November 12, 2015

Re: COPC Mapping White Paper – CPG Response — May 2007 Administrative Agreement and Order on Consent for Remedial Investigation/Feasibility Study – CERCLA Docket No. 02-2007-2009 (AOC)

RESPONSE TO REGION 2 WHITE PAPER ON CONTAMINANT MAPPING

LOWER PASSAIC RIVER STUDY AREA REMEDIAL INVESTIGATION/ FEASIBILITY STUDY

Figure 3-12a
Difference between Surface Concentration and Geomorphic Group Averages with Concentrations and Bathymetry for Reference
Contaminant Mapping Response
Lower Passaic River Study Area Remedial Investigation/Feasibility Study

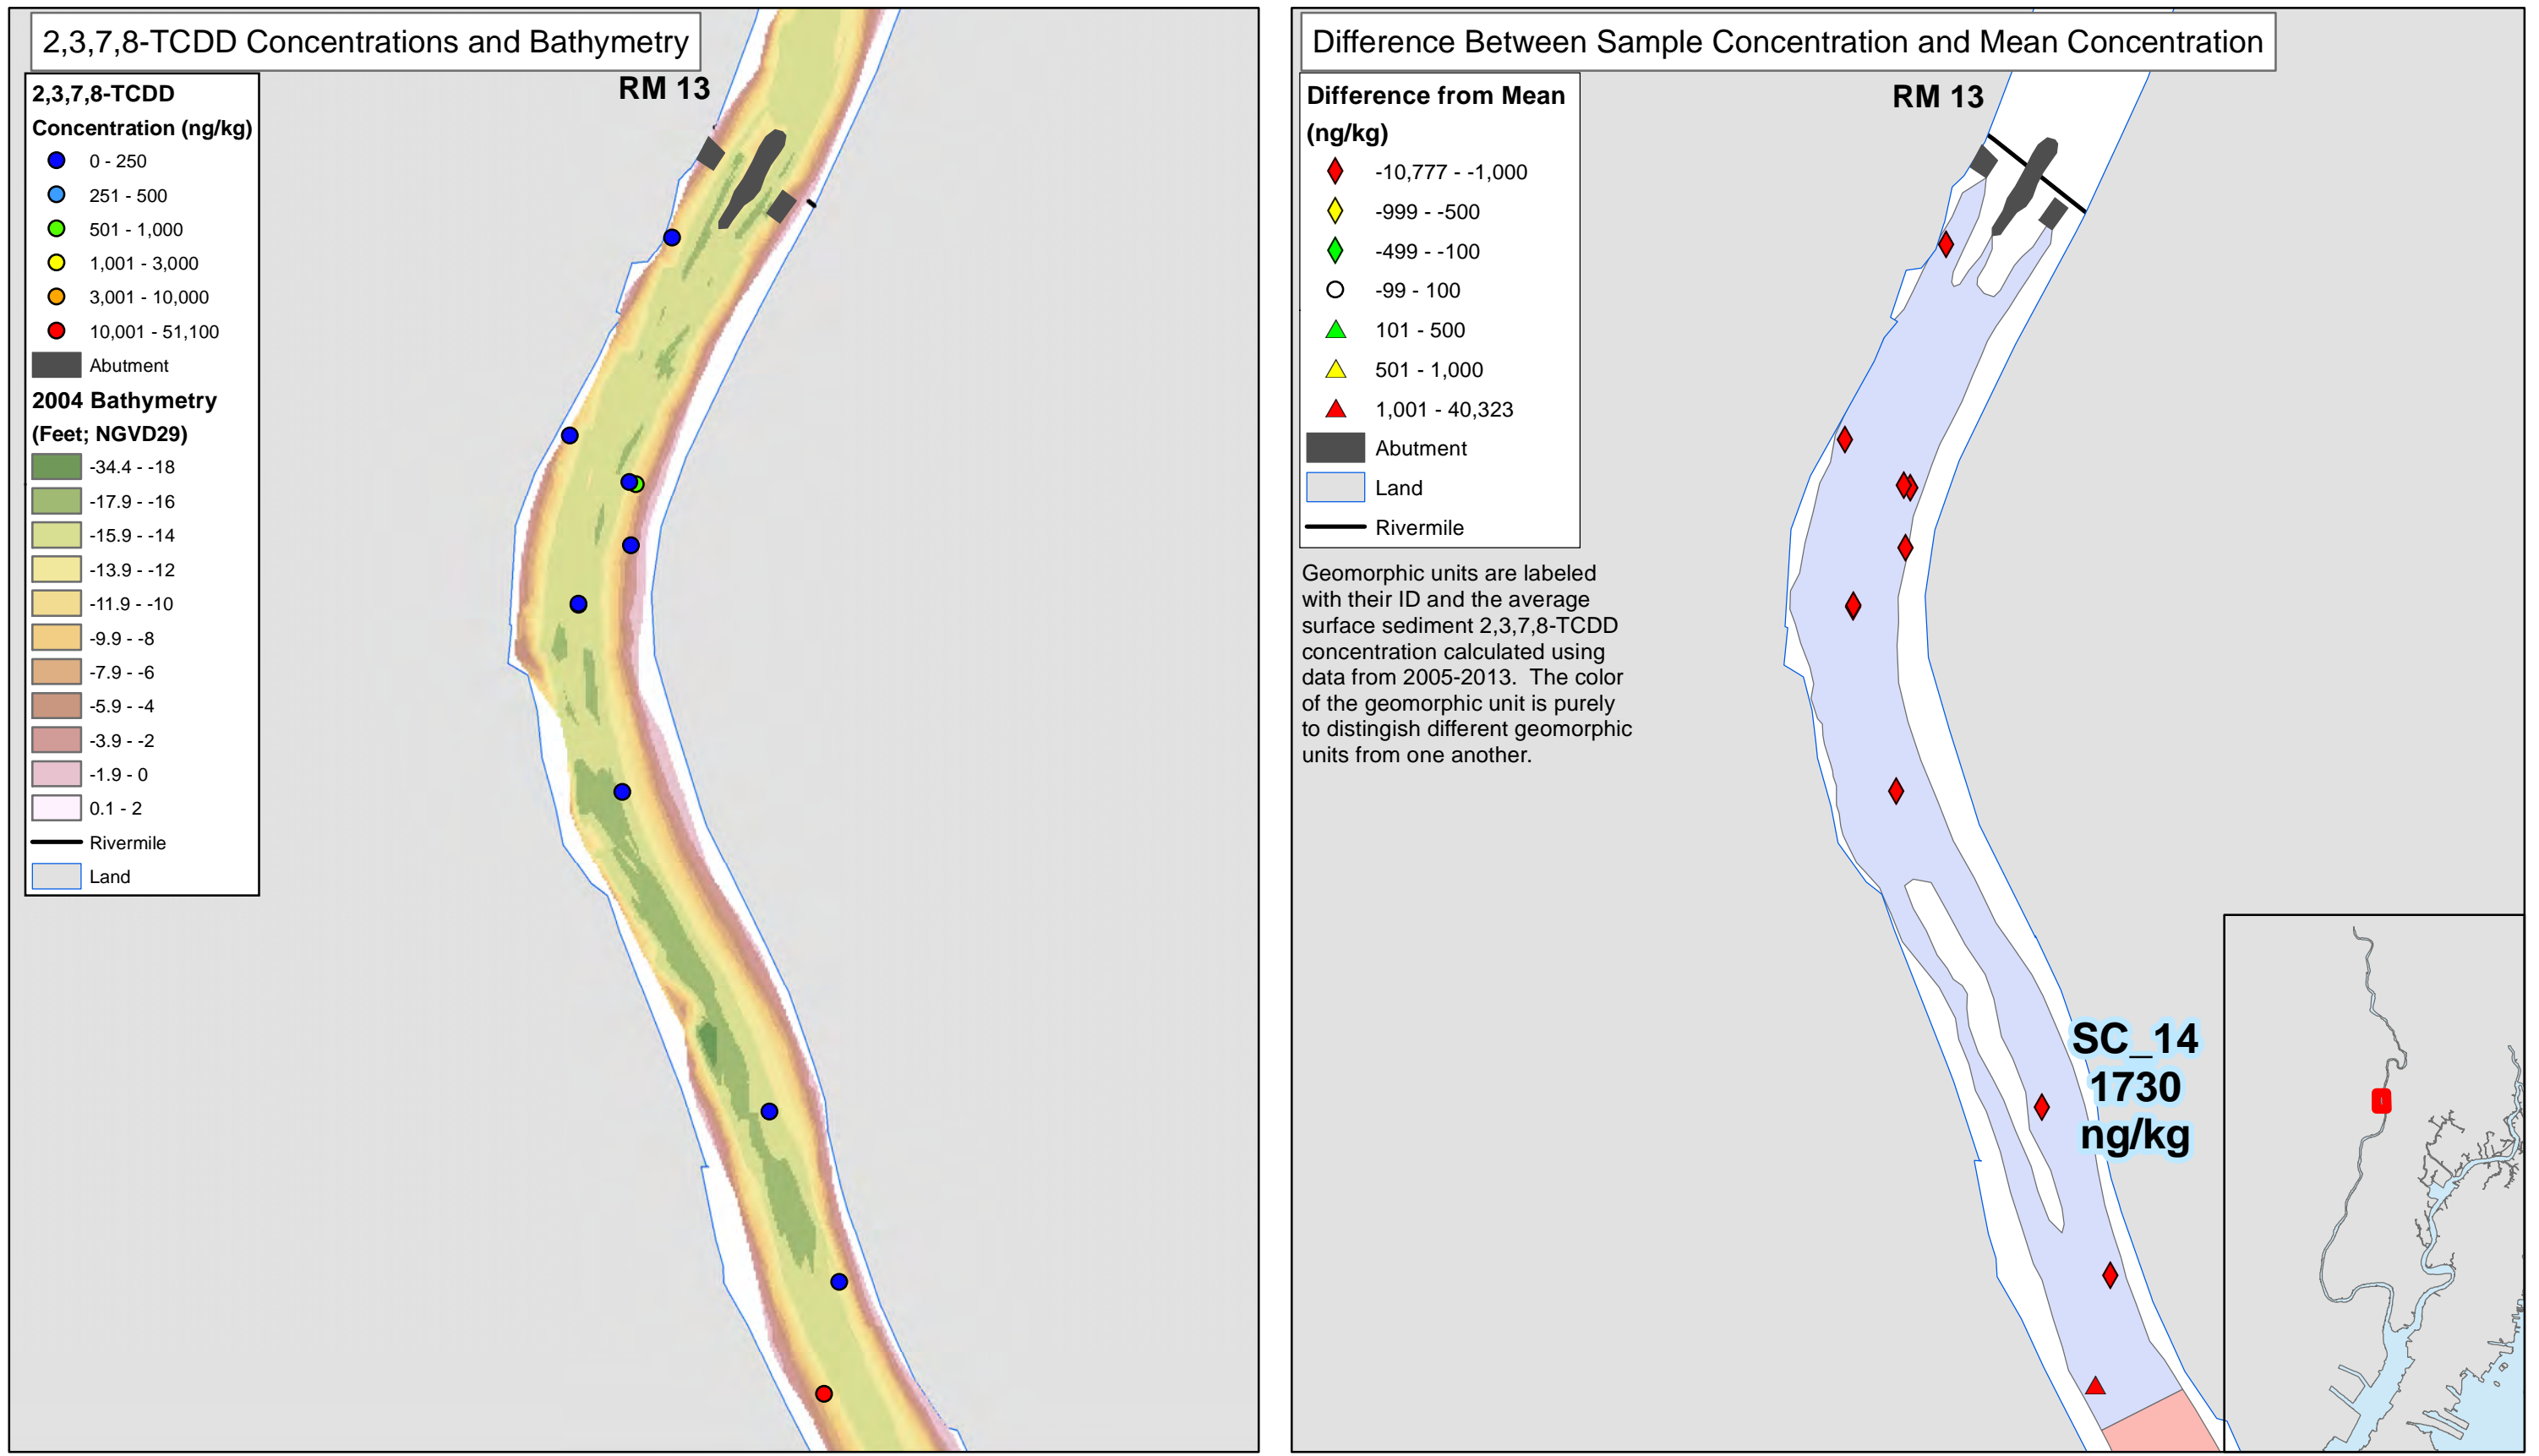
Eight out of the ten samples presented in Figure 3-12a have surface 2,3,7,8-TCDD concentrations less than 250 ng/kg. However, the average concentration of 1,730 ng/kg within this geomorphic region is inflated by a single high concentration sample at the extreme downstream edge of the geomorphic unit—using this average value for the entire unit results in all samples below the RAL being classified as above the RAL and misrepresents the concentrations by more than 1,000 ng/kg. The high concentration is from a silt pocket at that location—the rest of the region comprises coarser sediments (see Section 4.1 of the Draft 17-mile RI Report [Anchor QEA et al. 2015], which explicitly mentions this sample). Assigning an average concentration to the entire geomorphic region that is so heavily impacted by a single non-representative sample is fallacious.

Figure 3-12b
Difference between Surface Concentration and Geomorphic Group Averages with Concentrations and Bathymetry for Reference Contaminant Mapping Response
Lower Passaic River Study Area Remedial Investigation/Feasibility Study

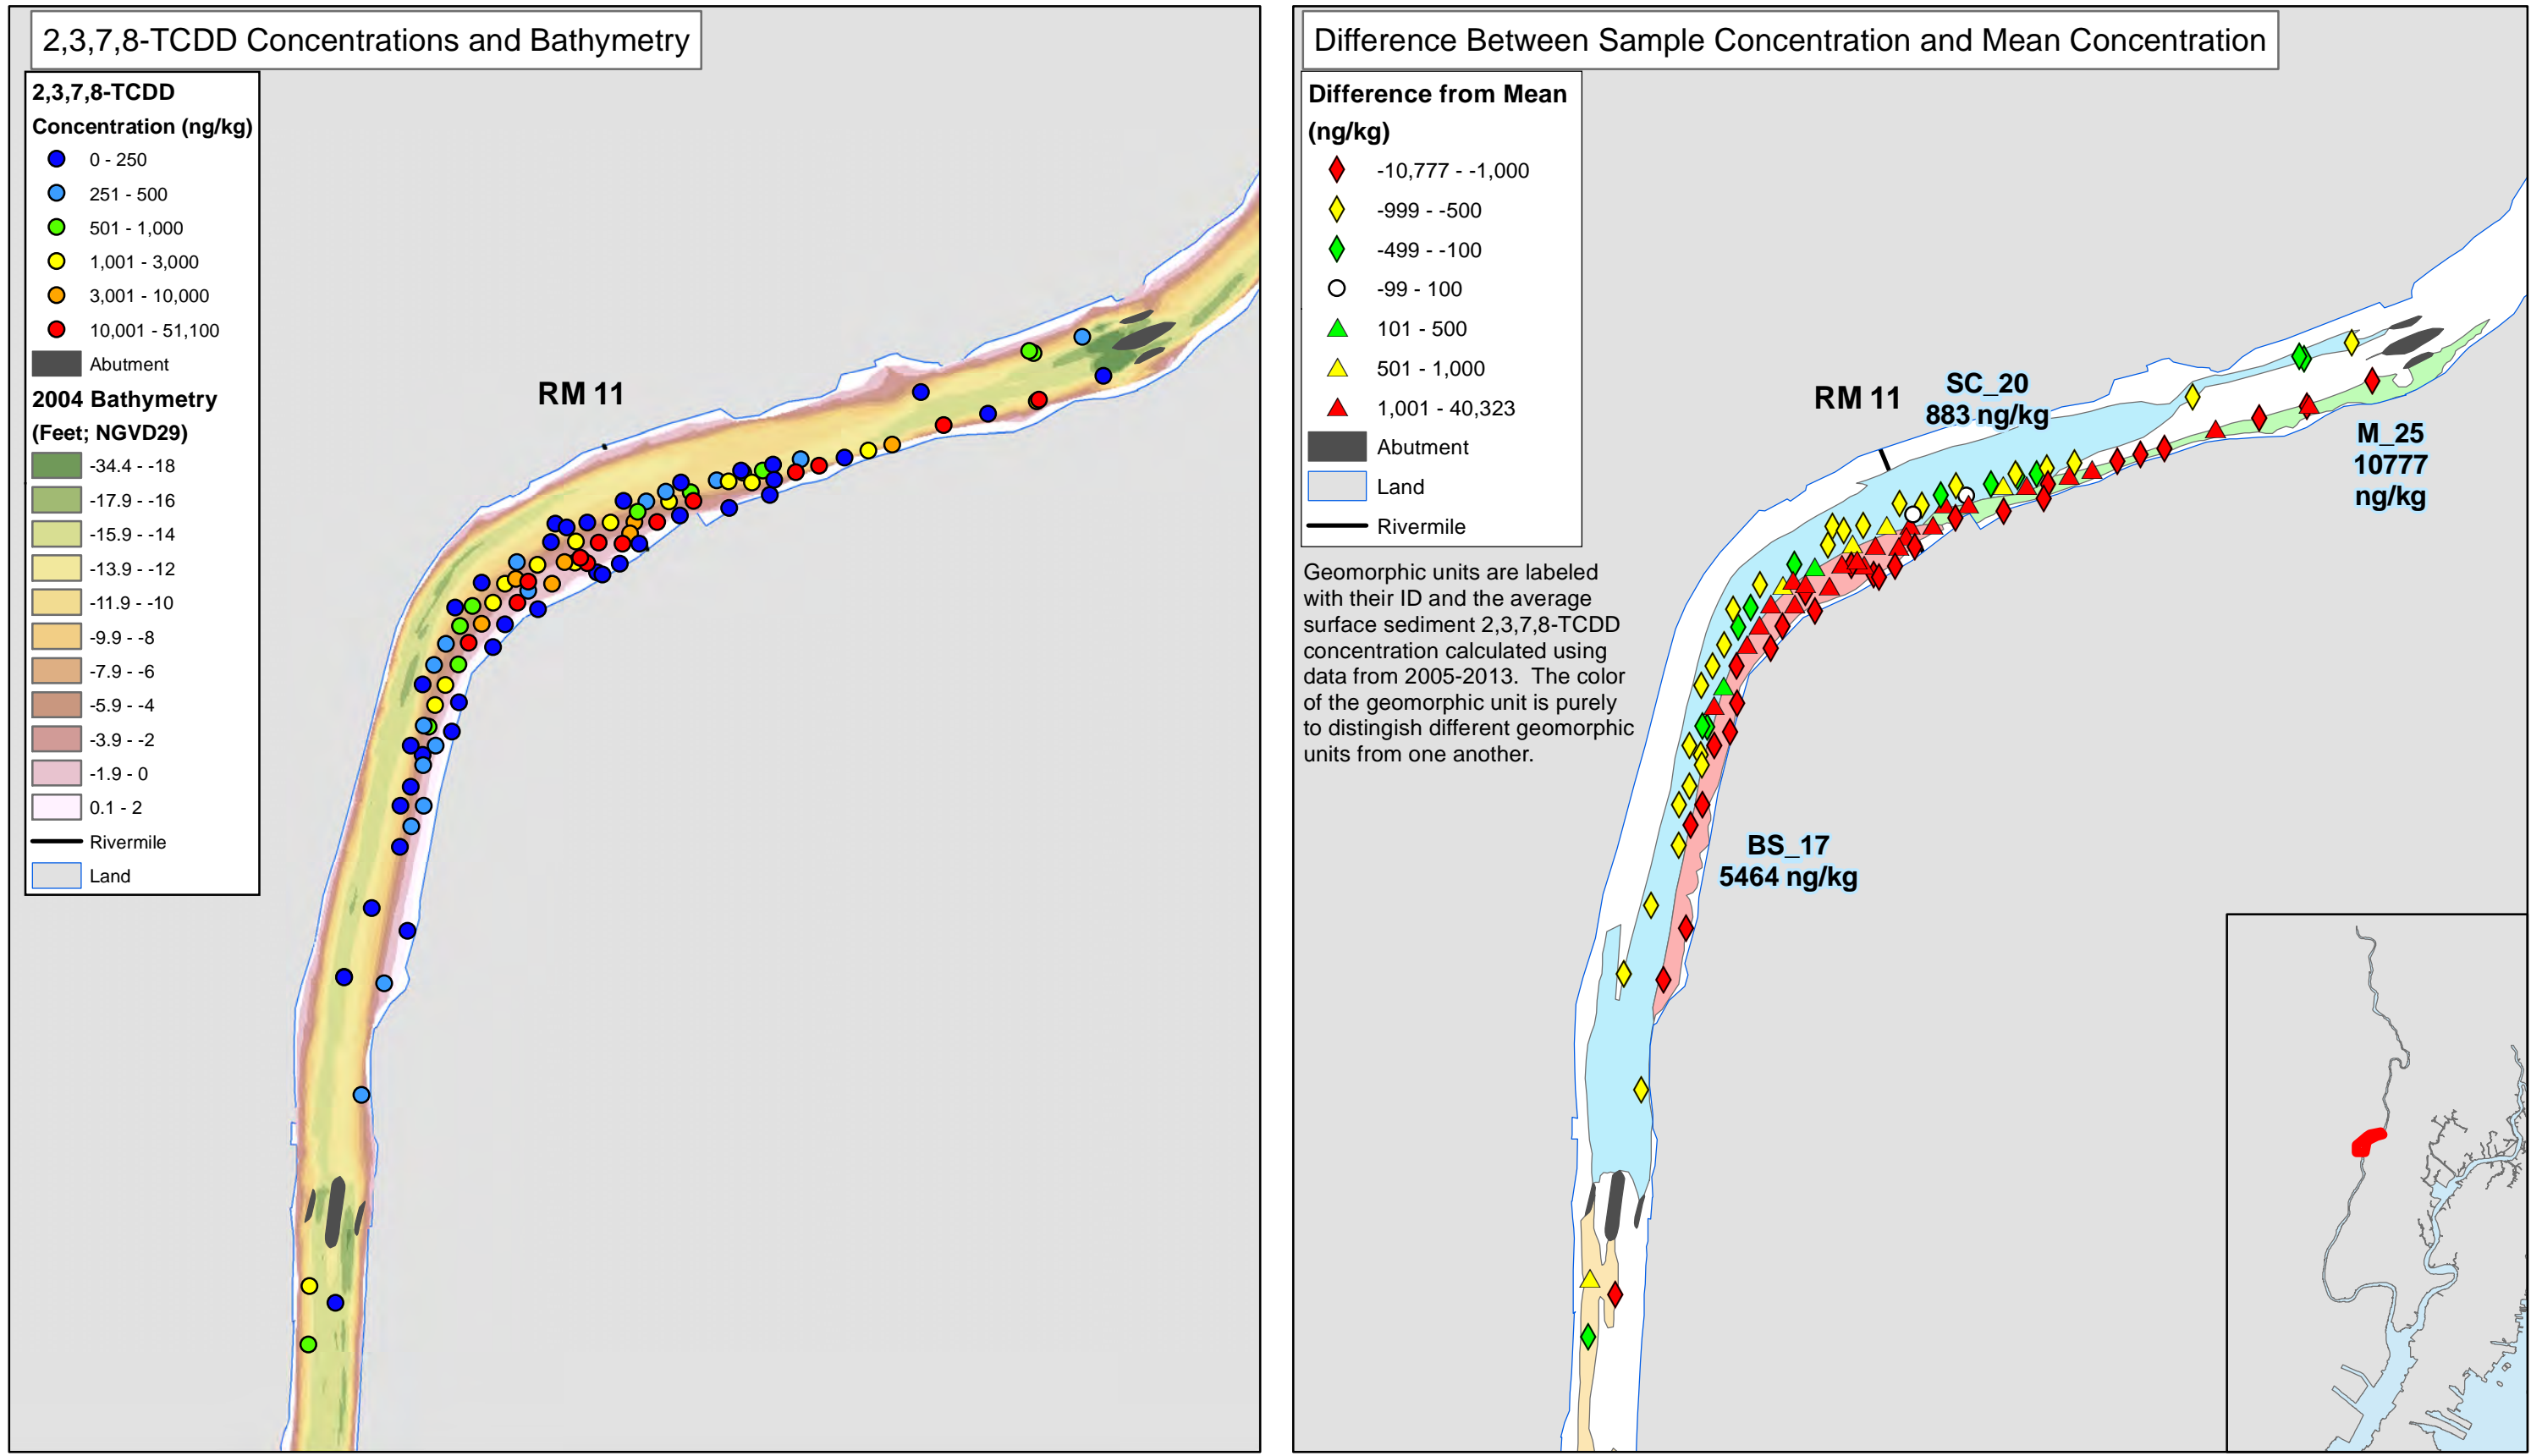
A similar set of maps are presented for the RM 10.9 area in Figure 3-12b. As discussed previously (Section 2.2; also Section 4.1 of the Draft 17-mile RI Report [Anchor QEA et al. 2015]), the surface contamination trends in the RM 10.9 point bar follow logically from the evolution of the point bar. Using a mapped average ignores the physical processes that form a point bar, resulting in significantly overestimating the concentrations at the downstream parts of the point bar, and significantly underestimating the concentrations in the upstream parts of the point bar.
